Final Supplemental Environmental Impact Report/ Environmental Impact Statement Oakland Harbor Deep-Draft Navigation Improvements

Appendix M Comments on the Draft SEIR/S

Appendix N Responses to Comments on the Draft SEIR/S

June 1994

Figure 5. Tidal prism attained with a dredged channel across the high outboard marsh. Highest tide shown in a), low tide in b). sill at 2.5 ft. (Longitudinal section through breach, elevations drawn to scale)

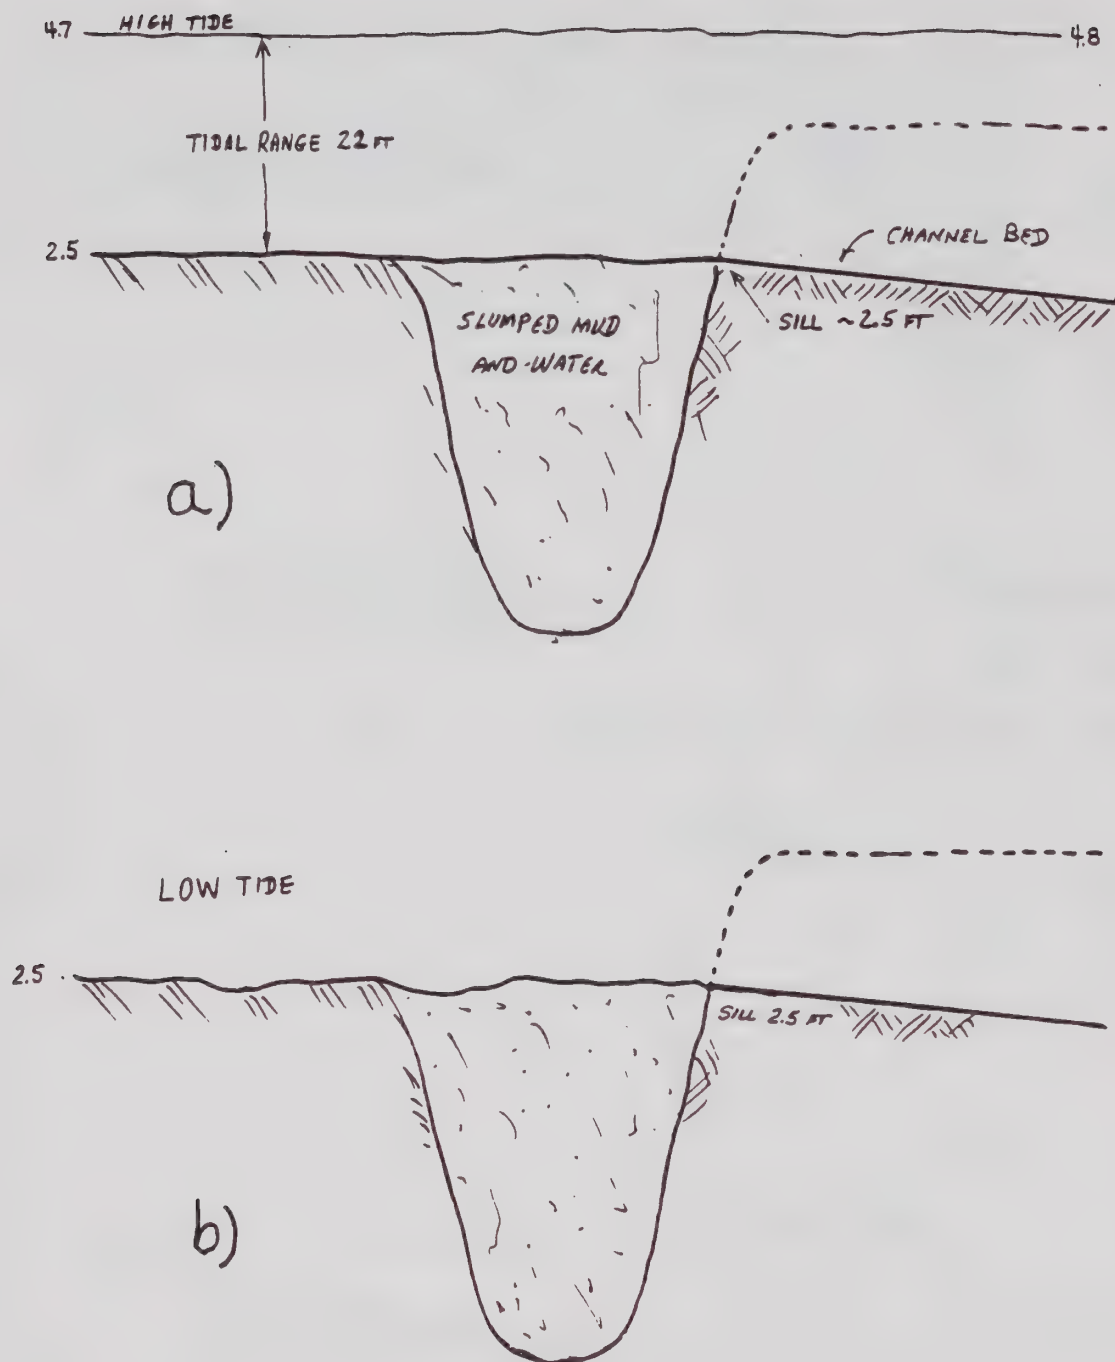
Figure 5 a), drawn again for the highest tide of the year, now shows the maximum level attainable almost matches the tidal elevation in the channel. In Figure 5 b), the tide has drained down to the 2.5 ft sill at the breach, yielding a range (and active prism) in the unit of 2.2 ft vs 0.64 ft without the dredged channel.
